# Access Compliance Report

## Public Rights-of-Way

### (Curb Ramps)

Intersection ID: N/A	Main Street: REA_RD	Cross Street: N/A	Location: NW
ADA ID: 0730D4F8C9E6	Ramp Type: Perp	Initial Pass/Fail: Pass	Overall Compliance: No
Codes/Mitigation Info/Possible Solution		Field Measurements/Component Compliance

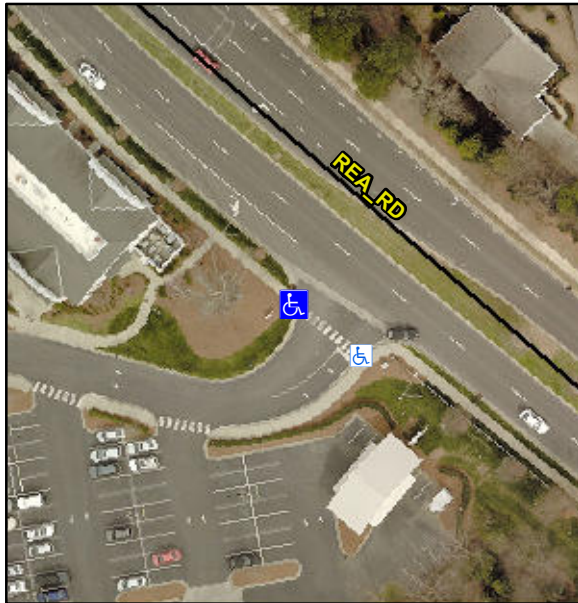
**Not Found, R304.2.1, R304.2.2-Perp, R304.3.2-Para, R304.5.3, R305.2**

**Remove & Replace Entire Ramp.**
